Meeting Agenda

Board of Zoning Appeals

Thursday, January 5, 2023

3. **Variance Request** To Allow Parking Within A Landscape Frontage Area, For The Property Located At 701 Cool Springs Boulevard (FZO §7.5).

C2.0

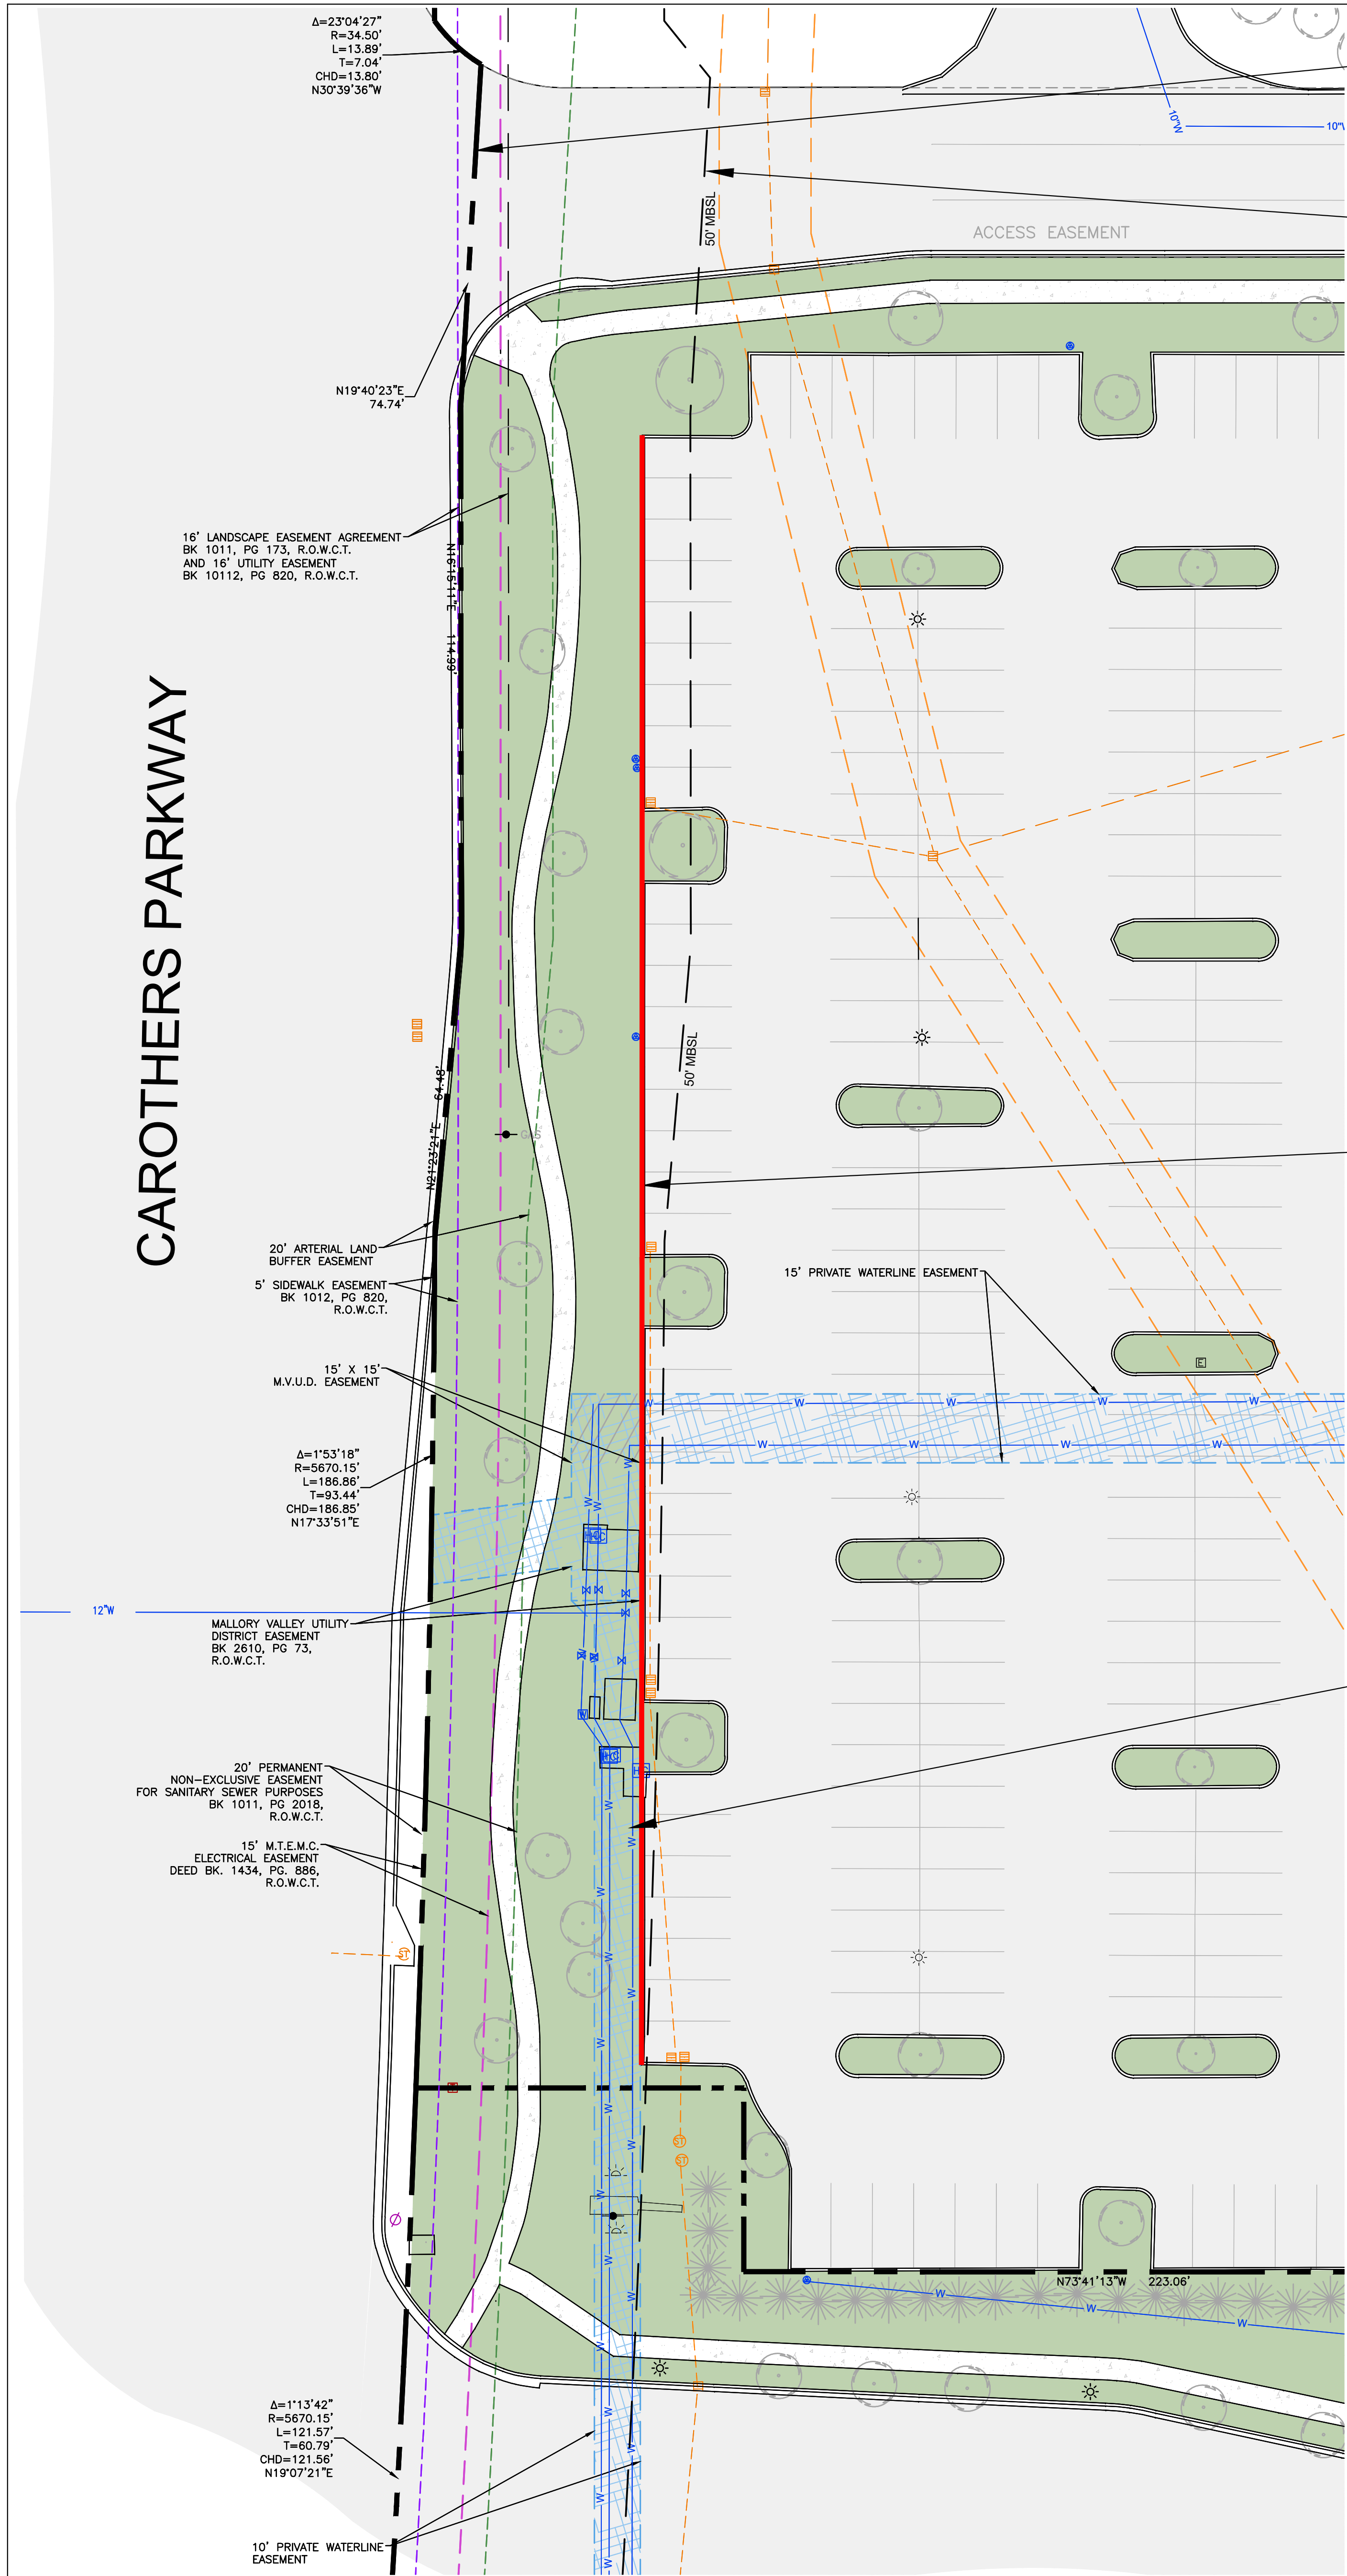
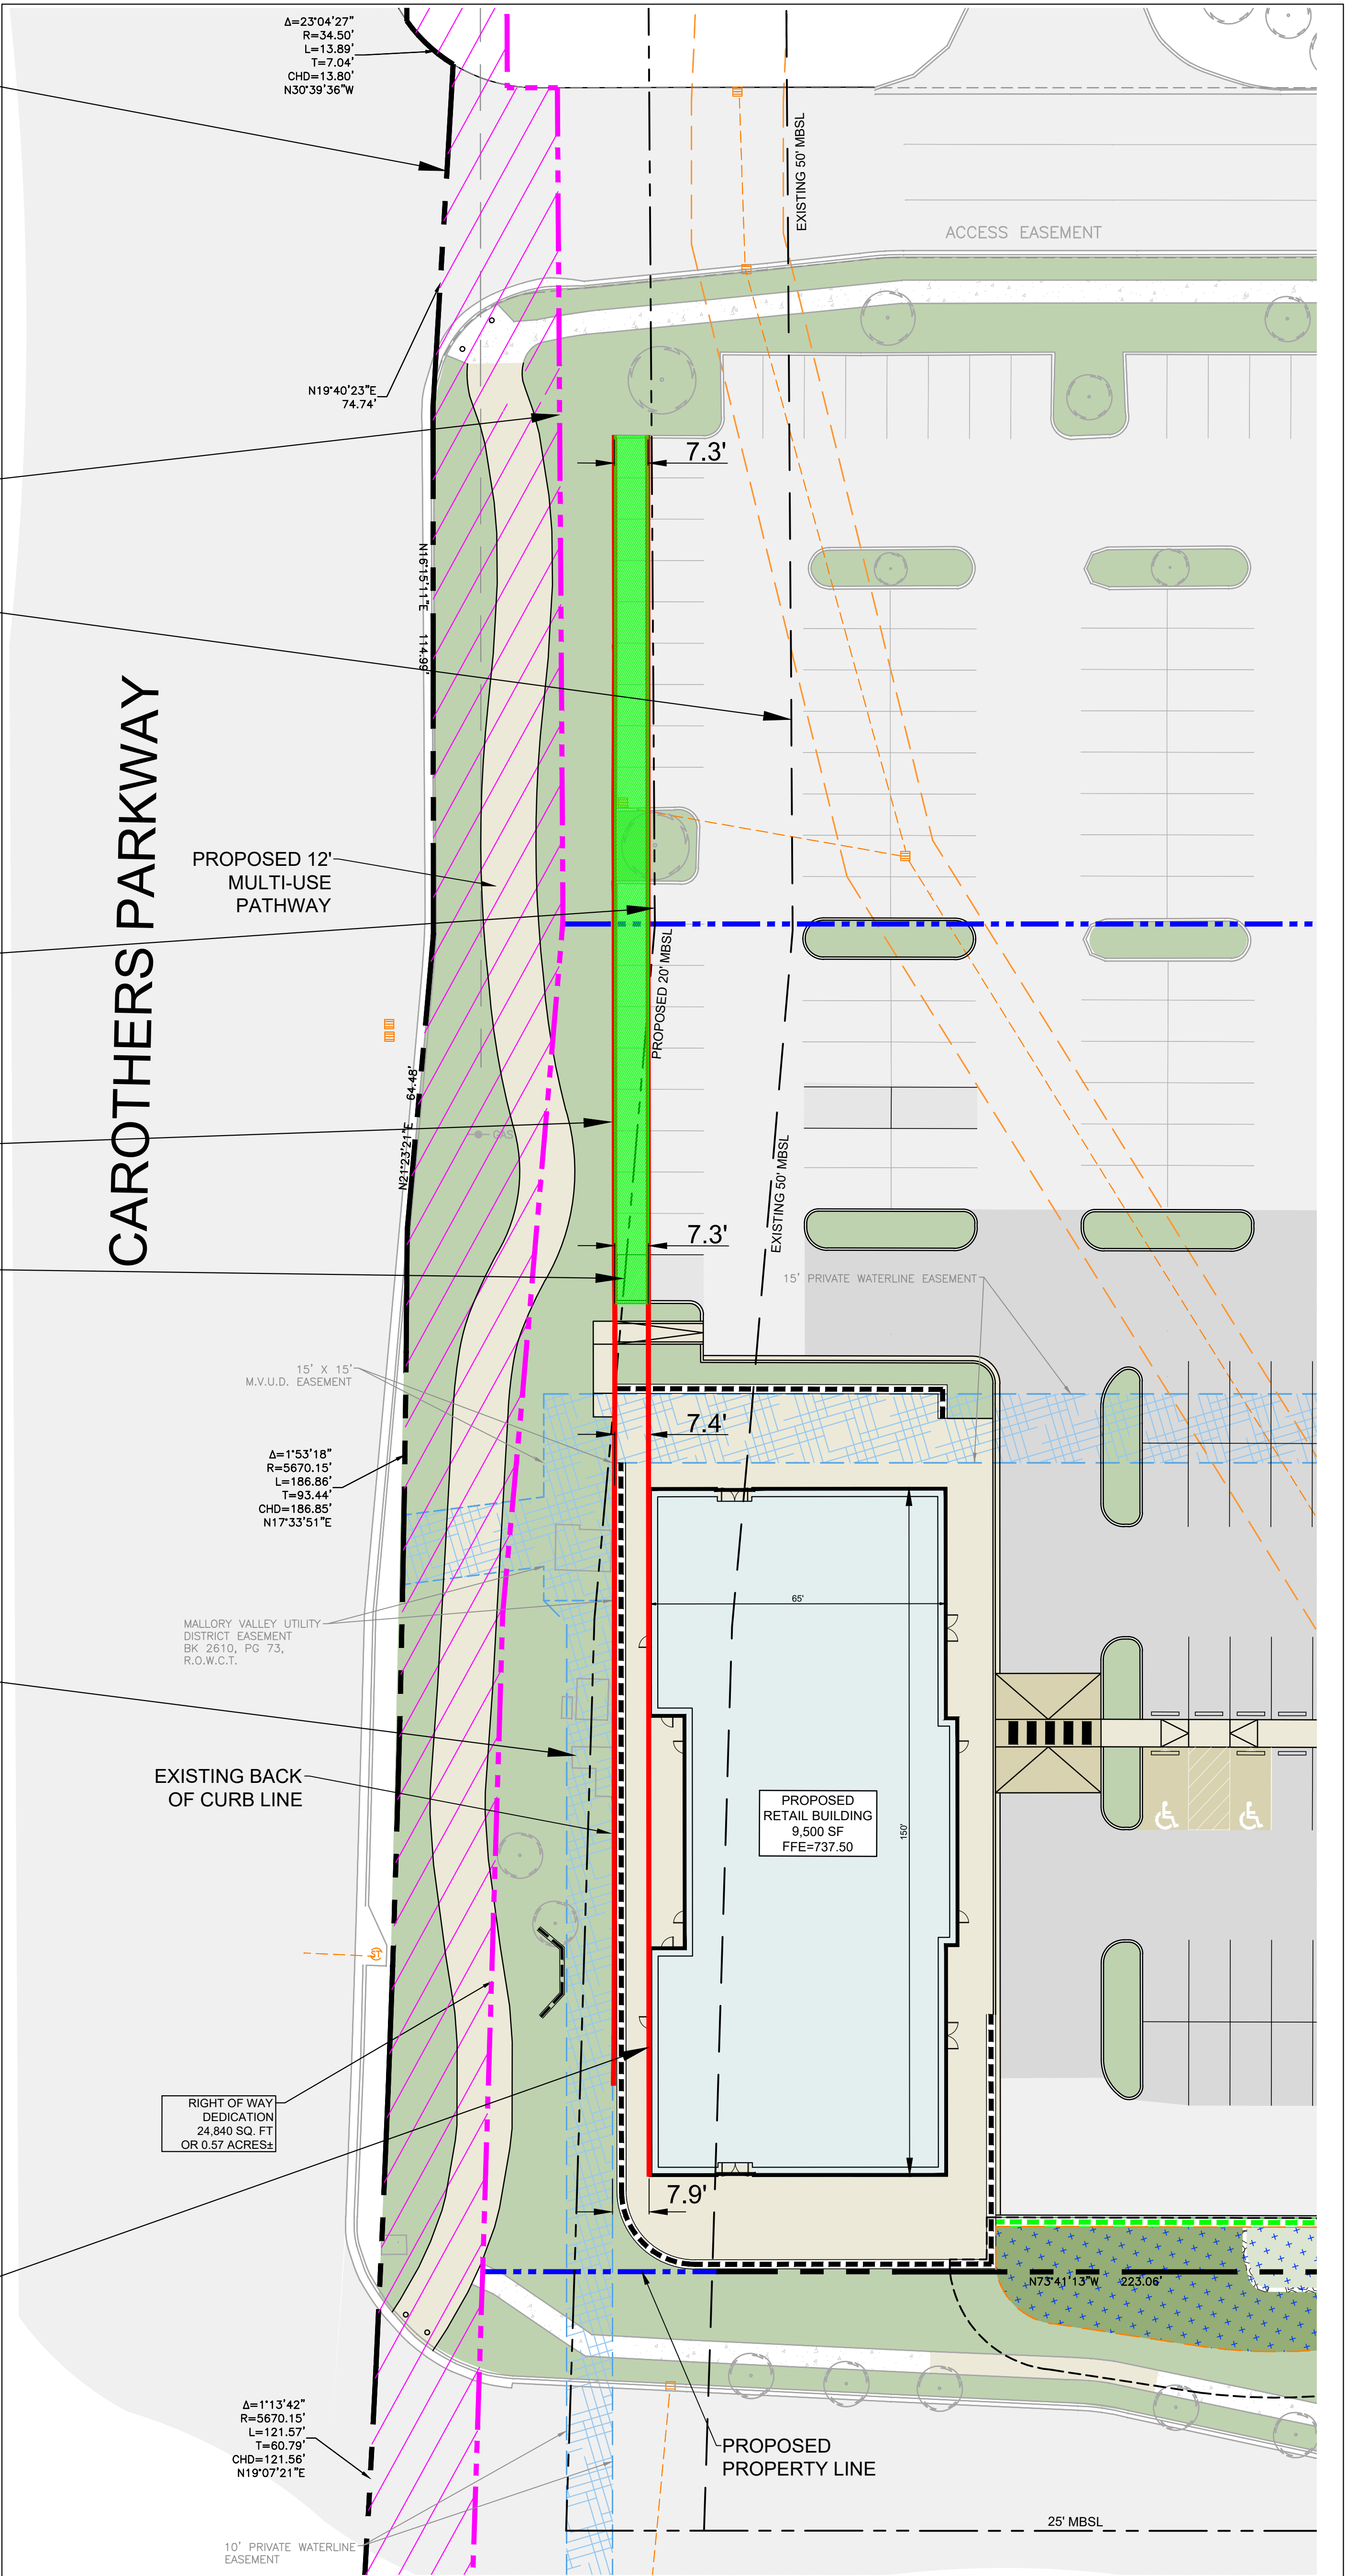
Staff finds that this proposed plan would not cause substantial detriment to the public good. Staff also finds that it would not impair the intent of the Zoning Ordinance. Because this proposal complies with the Zoning Ordinance in fronting Carothers Parkway and having sidewalk access to the front of the building, as well as trying to place the building as far forward as possible, it is evident that this proposal is deviating from the Zoning Ordinance in the smallest margin possible. This shows their effort to meet the intent of the Zoning Ordinance. Staff finds that this criteria is met.

Response: City of Franklin Zoning Ordinance Code 7.5 (Landscape Frontage); Due to existing public and private utilities and their associated easements and clearance requirements, we are not able to locate a proposed building's front façade (Carothers Parkway side) so that the adjacent existing parking is "no closer to the street than the front façade of a building". As such, the proposed building front façade is approximately 8' behind the adjacent existing parking, as shown in the supporting exhibit.

Further, the required minimum building setback line (MBSL) within the Unified Plan is currently 50'. This existing condition restricts the building's location ability to meet said Landscape Frontage requirement. While we are requesting a revision to the UDO to reduce this to a 20' MBSL to align with current RC12 policy, we are still unable to meet the parking frontage due to the existing location of said utilities and their associated easements. It should also be noted that the proposed building has several zoning and building code related items that restricts its ability to be located any closer to the required frontage alignment. Some examples would be the requirement to have doors along the front (Carothers Parkway facing side) and the required pathway to the doors along said frontage

SITE PLAN
AND NOTES

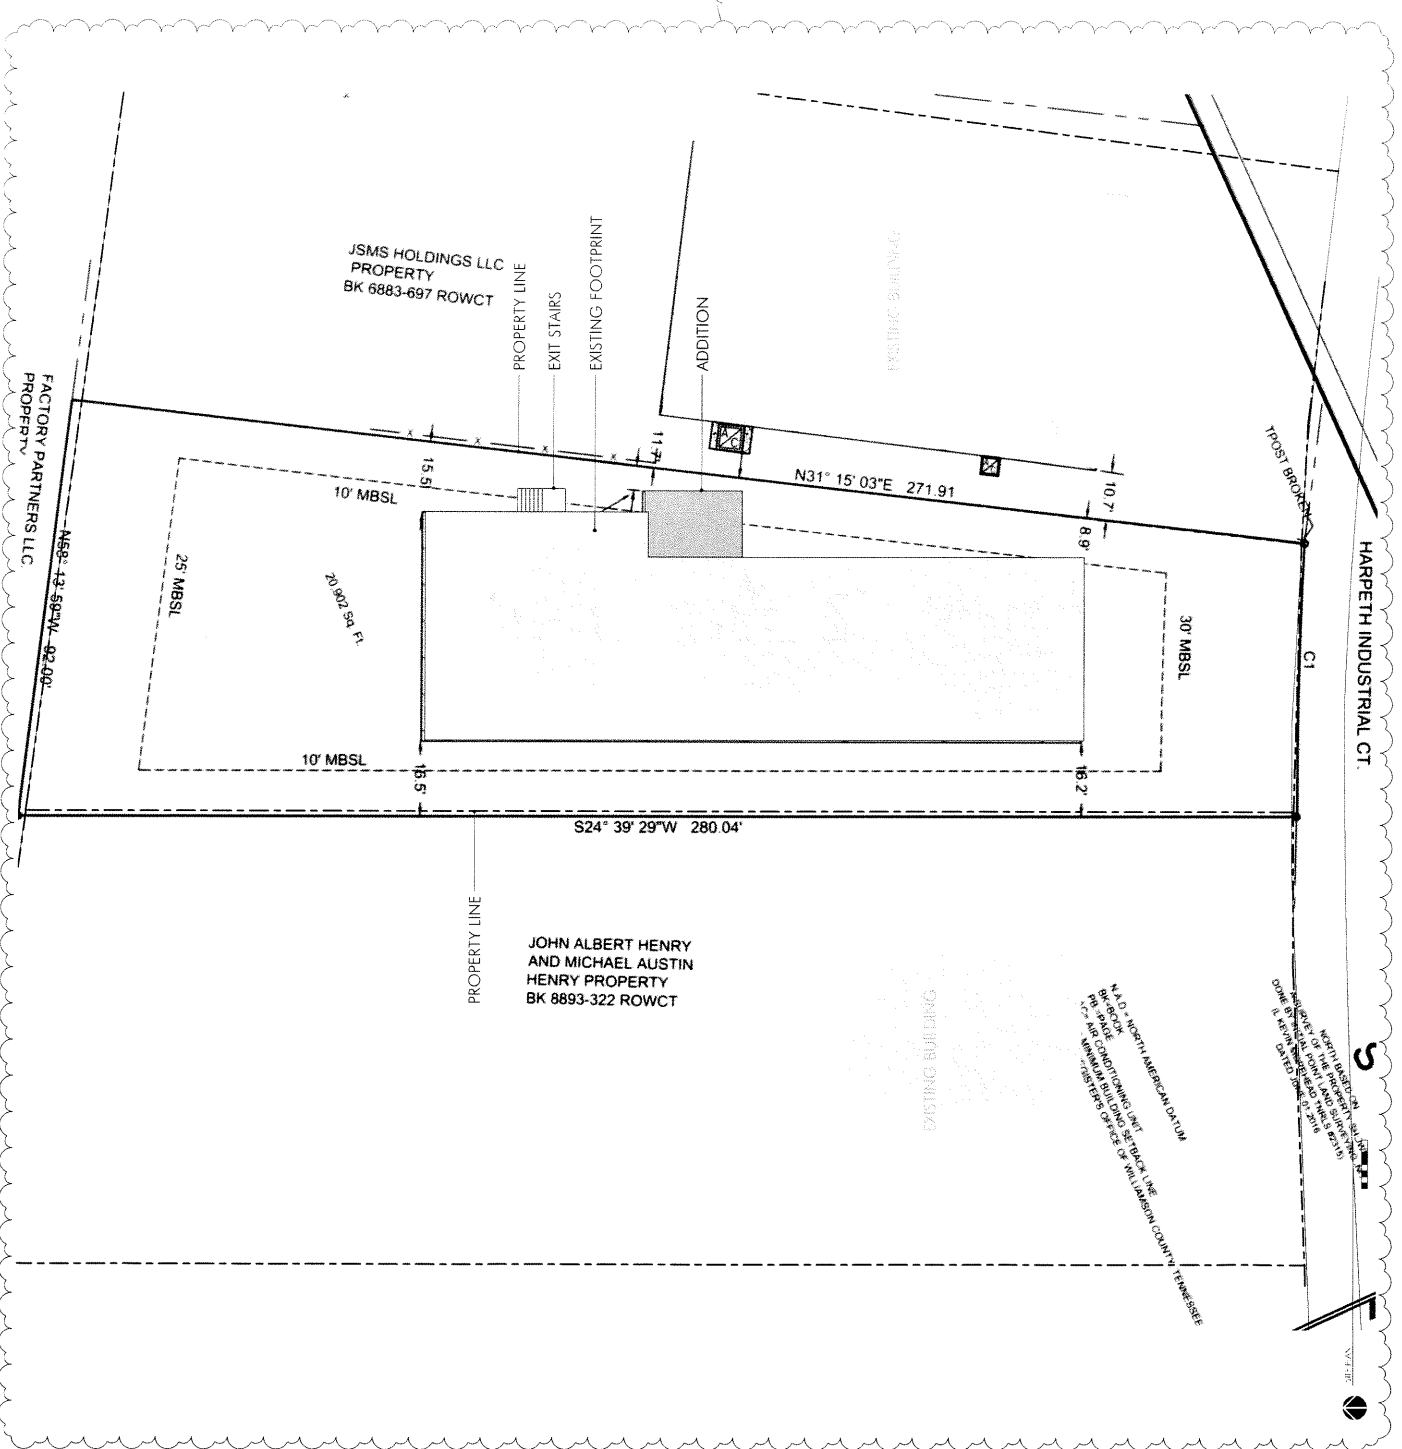
Staff finds that this proposed plan would not cause substantial detriment to the public good. Staff also finds that it would not impair the intent of the Zoning Ordinance. The intent of the Zoning Ordinance in this case is to maintain a buffer between buildings and their side lot line that is consistent along a street or within a neighborhood. Because of the strange shape of the lot, the addition that is encroaching into the setback is not much closer to the lot line than the original building, and visibility of the encroachment is very limited. Staff finds that this criteria is met.

RECOMMENDED MOTION: Staff recommends the Board of Zoning appeals move to approve the variance request to allow an encroachment with a maximum of 7 feet into a side yard setback, for the property located at 1108 Harpeth Industrial Court, because the criteria for granting a variance have been met.
